Document Information							
Document #	Document # 0201741/02-RCA-0272 Revision						
Title	QUARTERLY NOTIFICATION OF CLASS 1 MODIFICATIONS TO THE HANFORD FACILITY RESOURCE CONSERVATION AND RECOVERY ACT (RCRA) PERMIT, DANGEROUS WASTE PORTION (QUARTER ENDING MARCH 31, 2002 - PERMIT CONDITION I.C.3)						
Date	04/09/2002						
Originator	J. HEBDON, R. H. GURSKE, R. D. (ROBY) EN	Originator Co.	DOE, FH, PNNL				
Recipient	L. E. RUUD	Recipient Co.	DOEC				
References			<u> </u>				
Keywords							
Projects							
Other Information

QUARTERLY NOTIFICATION OF CLASS 1 MODIFICATIONS TO THE HANFORD FACILITY RESOURCE CONSERVATION AND RECOVERY ACT (RCRA) PERMIT DANGEROUS WASTE PORTION (QUARTER ENDING MARCH 31 2002 – PERMIT CONDITION I C 3)

Part III Chapter 4 and Attachment 34 Liquid Effluent Retention Facility and 200 Area Effluent Treatment Facility

2 88766 3 6 CL UHLMAN Mok Frieder 648330 77

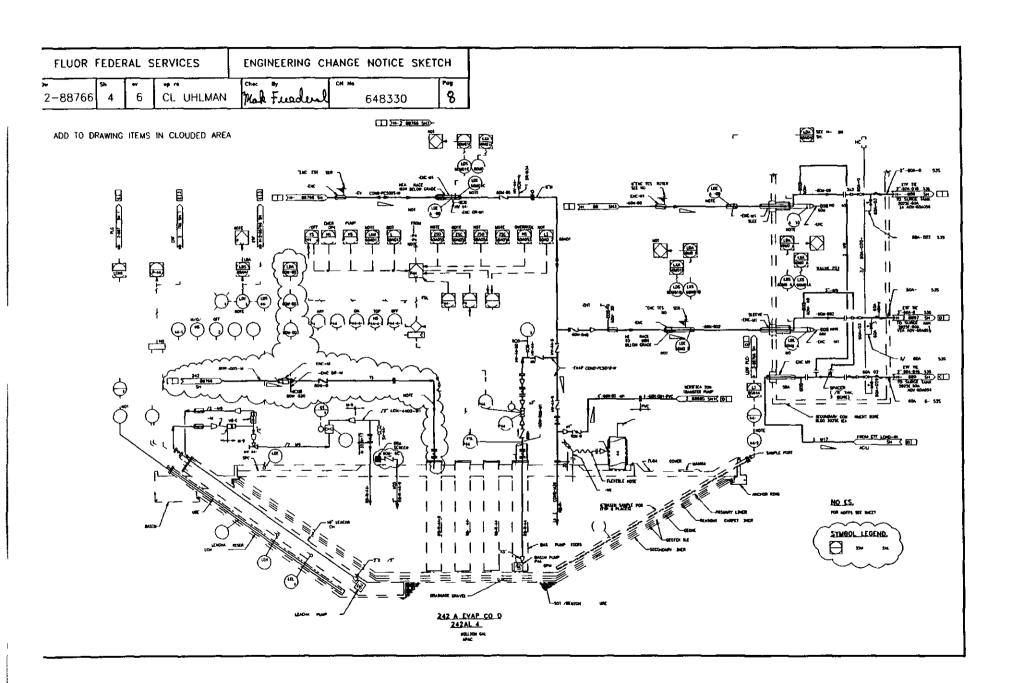
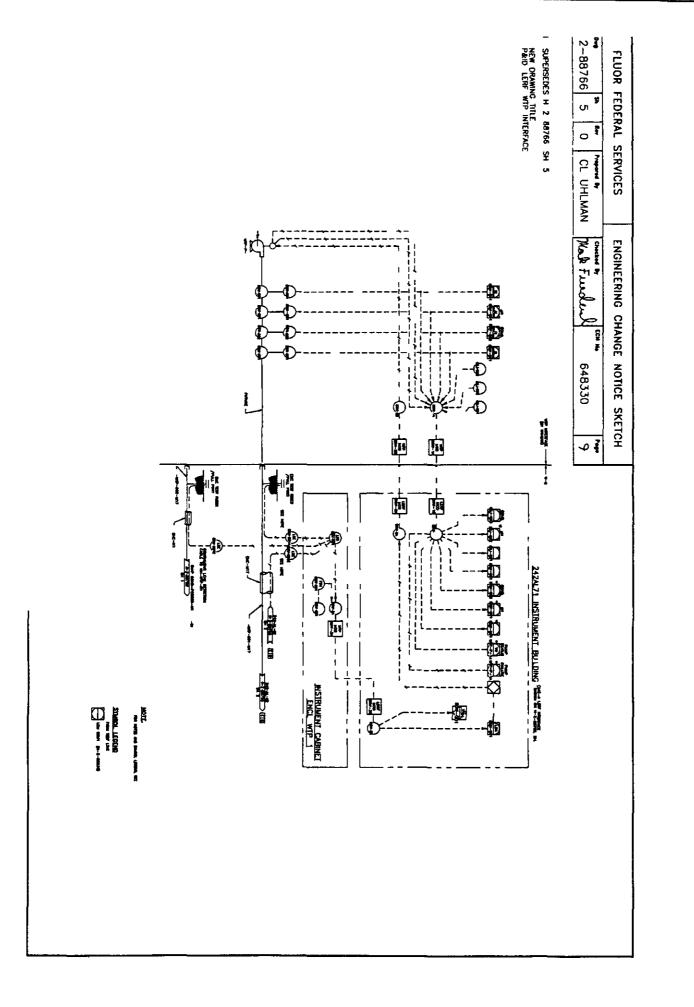
ADD ITEMS IN CLOUDED AREA AS SHOWN

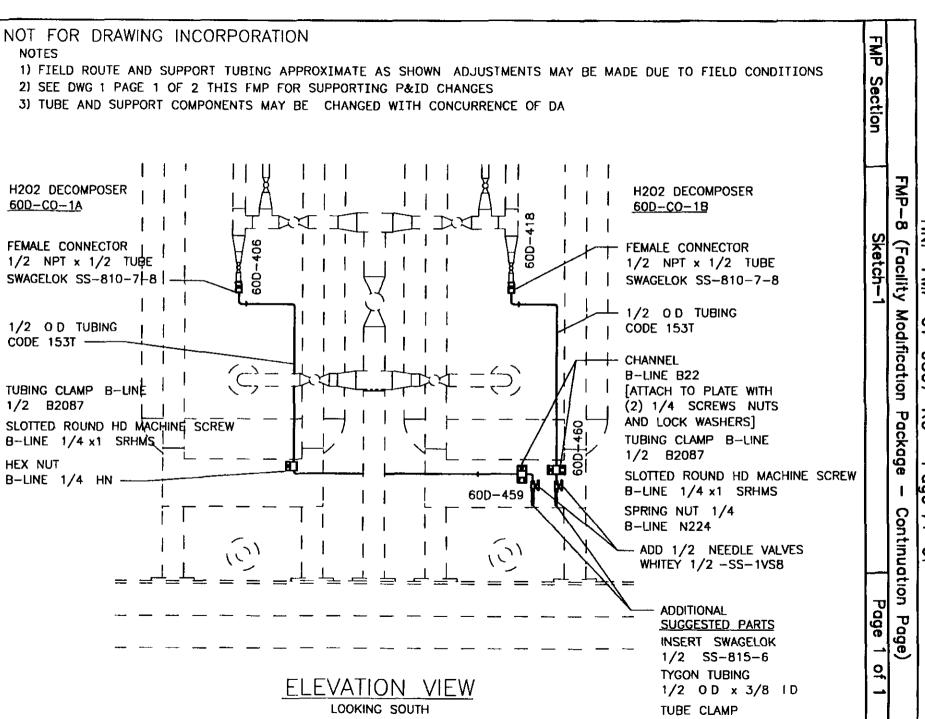
HNF-FMP-01-9507-R0 Page 18 of 30 FMP-8 (Facility Modification Package - Continuation Page) DWG-3 Page 1 of 1 FMP Section H-2-89351 SH1 ZONE E3 REVISE AS SHOWN CAP SCREWED
OR QUICK DISCONNECT
OR TELL TALE WITH CLAMP "IS" CAP SCREWED "WAS" OR QUICK DISCONNECT H-2-88988 SH 1 ZONE F8 ADD VALVE V-16 AND V-17 AS SHOWN V-16 = V-AIT60J012A-G ZONE C6 V-17 = V-AIT60J012B-G, ZONE C3 H-2-88988 SH 1 ZONE C6 AND C3 REVISE AS SHOWN IN CLOUDED AREA (ADD NEEDLE VALVE WHITEY 3/8 -SS-1VS6 AND 3/8 O.D. TUBING CODE 153T) ADDITIONAL SUGGESTED PARTS 3/8 INSERT SWAGELOK SS-605-4 TYGON TUBING 3/8 OD x 1/4 ID AND TUBE CLAMP AREA OF CHANGE "IS"

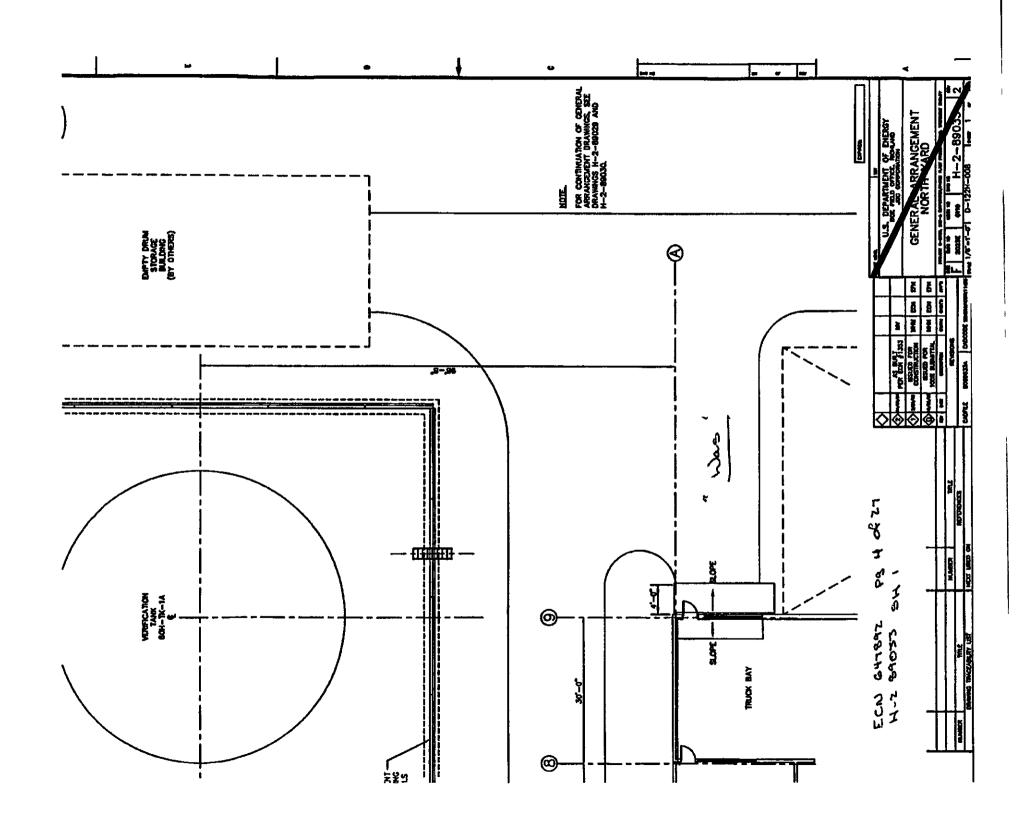
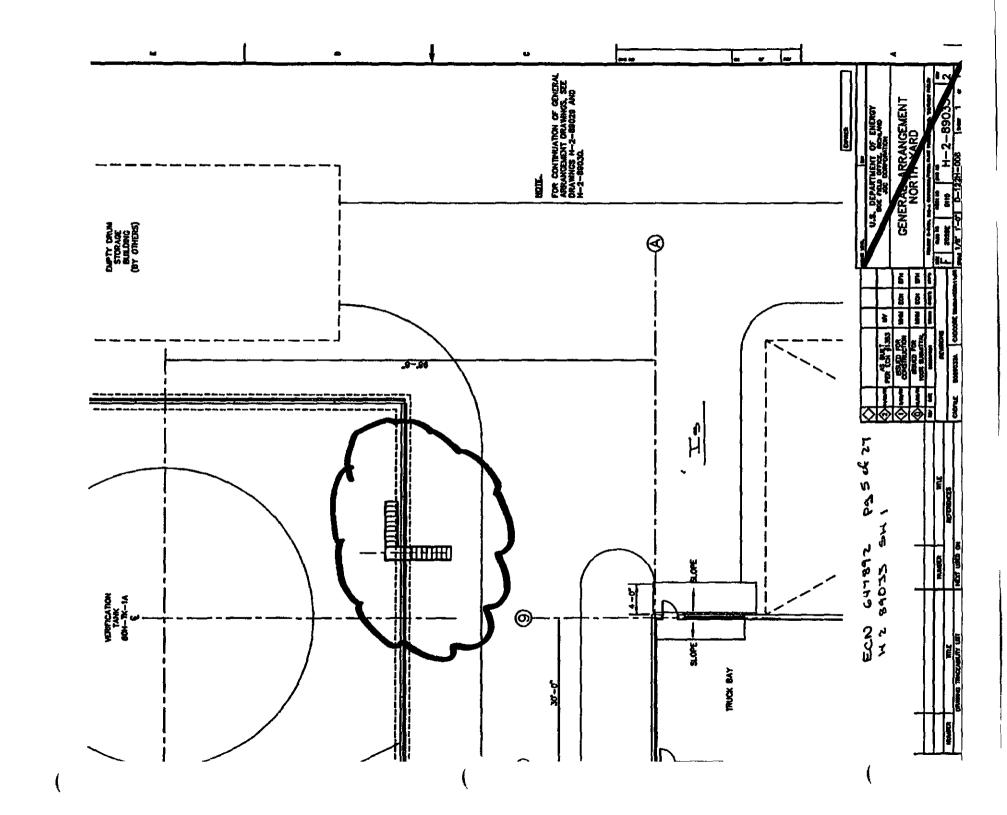
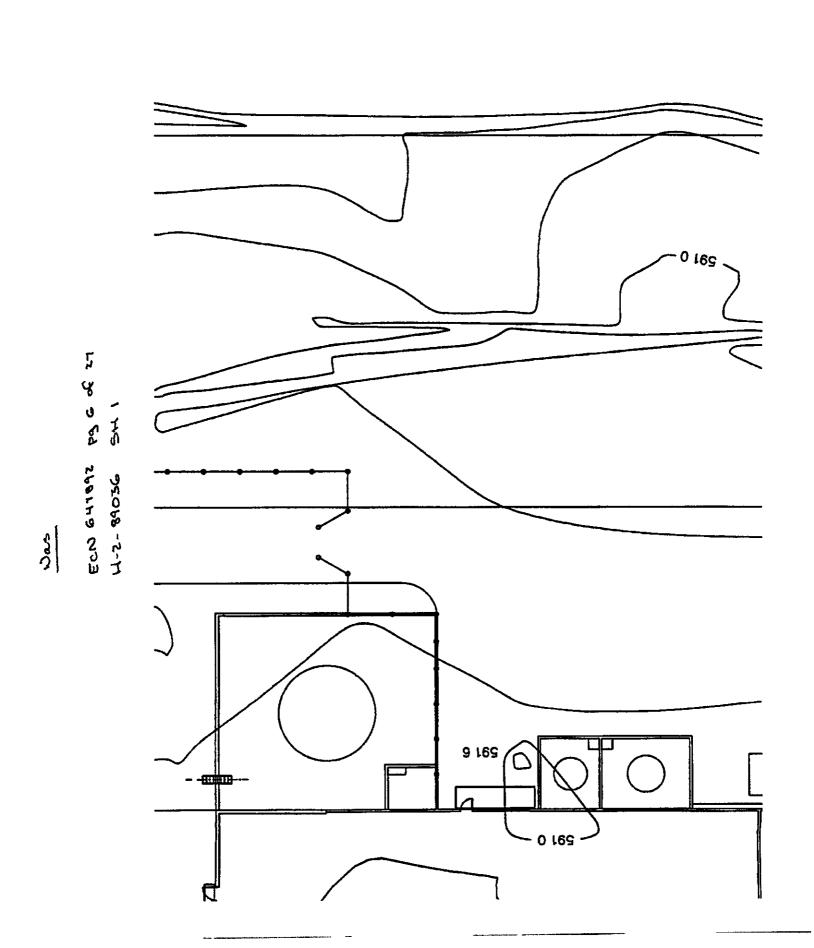
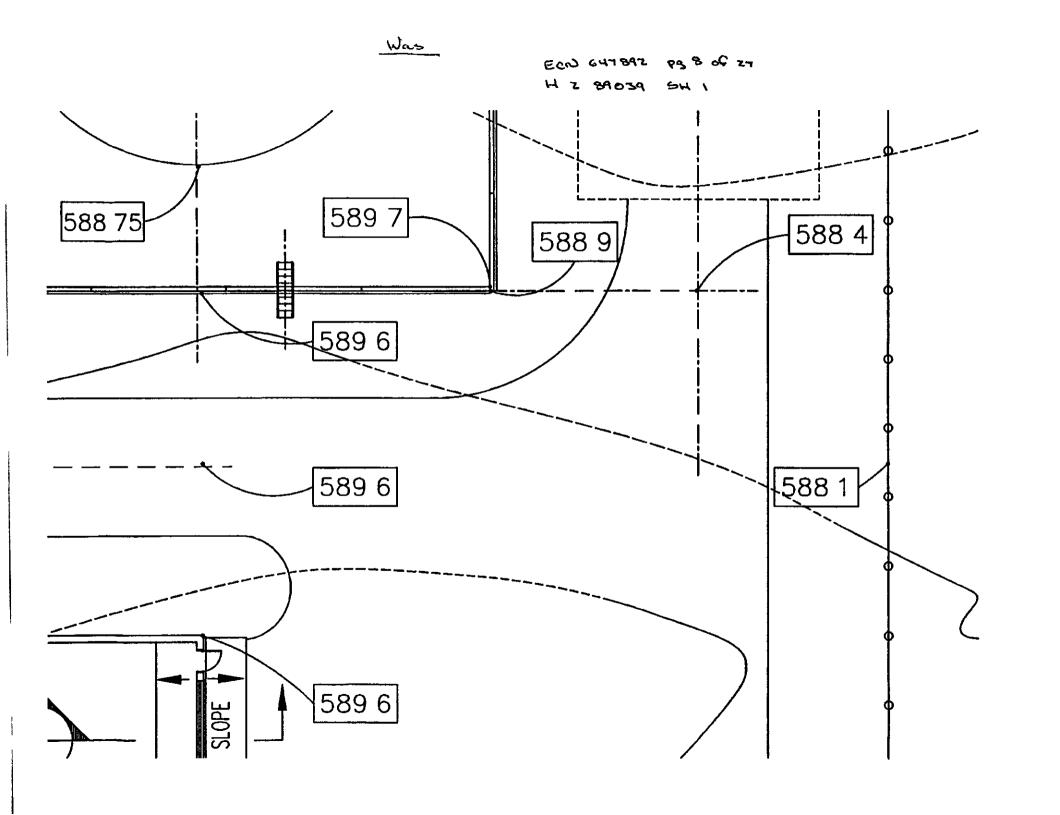
ECN 647892
ENGINEERI	ING CHANGE NOT	TICE CONTINUATION SHEET Page 3 of 27 Date 9/21/98
H-2-89033, S	h 1, Zone D-3	Replace ladder with stairway
H-2-89036, S	h 1, Zone E-4	Replace ladder with stairway
H-2-89039, S	h 1, Zone B-4	Replace ladder with stairway & show new sidewalk
	Zone E-4	Replace ladder with stairway
H-2-89040 S	h 1, Zone B-4	Replace ladder with stairway & show new sidewalk
	Zone E-4	Replace ladder with stairway
H-2-89044, S	h 1, Zone B-4	Replace ladder with stairway & show new sidewalk
	Zone E-4	Replace ladder with stairway
'	ladder & crosso	Replace ladder with stairway Delete 8'-9" dimension and ver centerline callout Change Section 4, Dwg 89069 "See Section For Foundation Information"
	dimensions, lan	Replace ladder with starrway Delete 10'-0" & 3'-5 1/2 ding and ladder & crossover centerline callout Change "See Section For Foundation Information" with reference to tion 4
	callout Chang Foundation (Loc "Aluminum Pre-E	Add "minimum" to foundation width dimension (2'-0") e foundation text to read "Ladder Or Stairway Concrete ate In Field)" Change ladder description text to read ingineered Ship Ladder With Platform & Return, O'Keefe's Equal, Or Aluminum Pre-Engineered Stairway See VI Supp way Detail "

H-2-89078, S	h 1, Zone A-7	Change detail title to "Ladder Or Stairway Step Off Pad"
	Zone B-6	Change callout to "Ladder Or Stairway" from "Ladder"
	Zone B-7	Add "minimum" to step off pad length dimension (38")
	Zone B-8	Add "minimum" to step off pad width dimension (30")

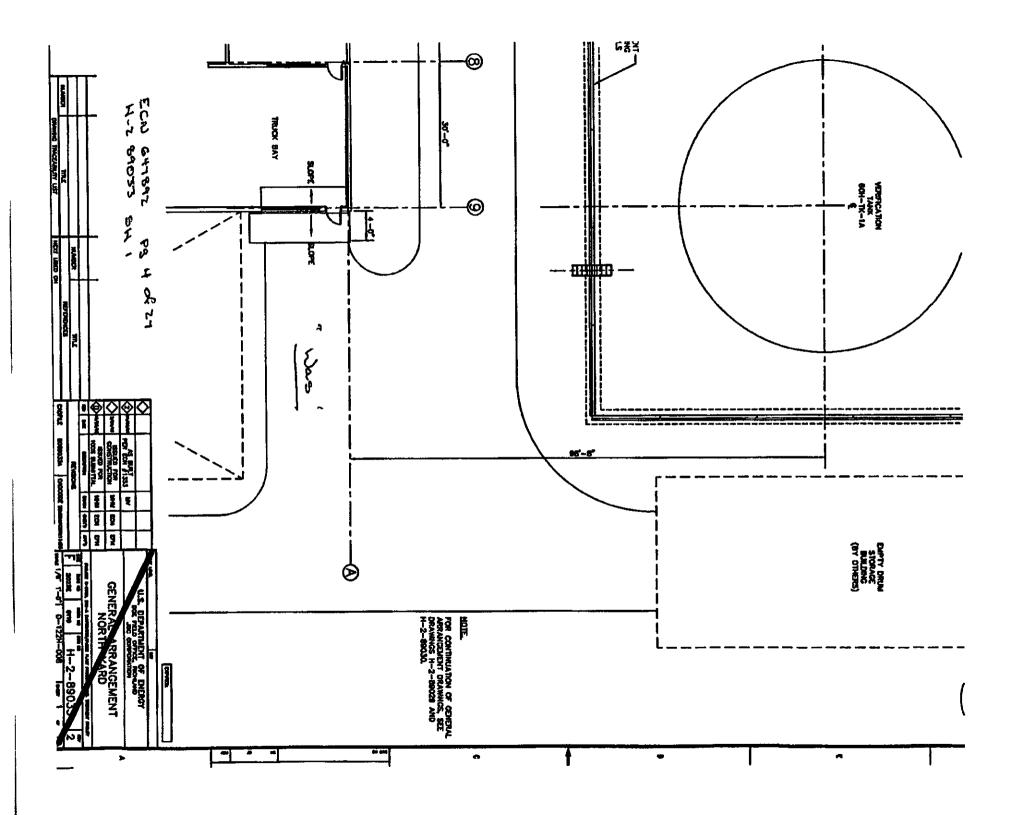
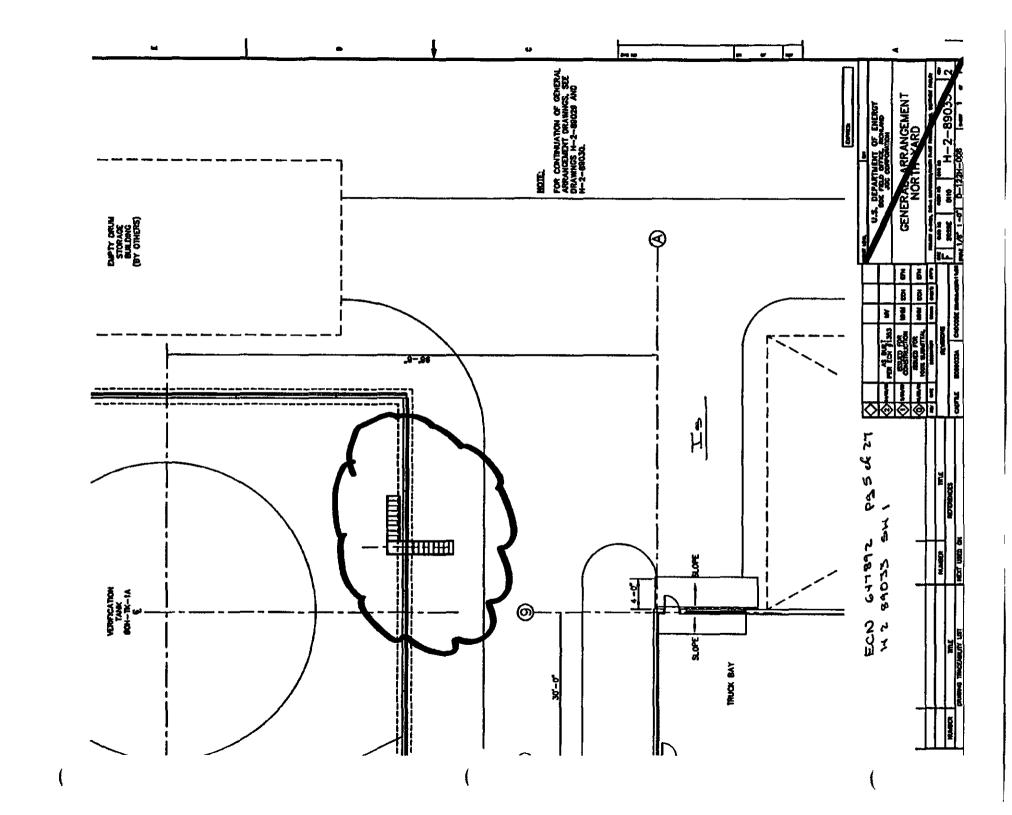
ENGINEE	RING CHANGE NO	TICE CONTINUATION SHEET
 		Page 3 of 27 Date 9/21/98
H-2-89033,	Sh I, Zone D-3	Replace ladder with starrway
H-2-89036,	Sh 1, Zone E-4	Replace ladder with stairway
H-2-89039,	Sh 1, Zone B-4	Replace ladder with stairway & show new sidewalk
	Zone E-4	Replace ladder with stairway
H-2-89040	Sh 1, Zone B-4	Replace ladder with stairway & show new sidewalk
	Zone E-4	Replace ladder with stairway
H-2-89044,	Sh 1, Zone B-4	Replace ladder with stairway & show new sidewalk
	Zone E-4	Replace ladder with stairway
H-2-89063,	ladder & crosso	Replace ladder with stairway Delete 8'-9" dimension and over centerline callout Change Section 4, Dwg 89069 i "See Section For Foundation Information"
H-2-89068,	dimensions, lan	Replace ladder with stairway Delete 10'-0" & 3'-5 1/2" ding and ladder & crossover centerline callout Change "See Section For Foundation Information" with reference to ction 4
H-2-89069,	callout Chang Foundation (Loc "Aluminum Pre-E	Add "minimum" to foundation width dimension (2'-0) ge foundation text to read "Ladder Or Stairway Concrete cate In Field)" Change ladder description text to read Engineered Ship Ladder With Platform & Return, O'Keefe's Fequal, Or Aluminum Pre-Engineered Stairway See VI Supprway Detail "

H-2-89078,	Sh 1, Zone A-7	Change detail title to "Ladder Or Stairway Step Off Pad"
	Zone B-6	Change callout to "Ladder Or Stairway" from "Ladder"
	Zone B-7	Add "minimum" to step off pad length dimension (38")
	Zone 8-8	Add "minimum" to step off pad width dimension (30")
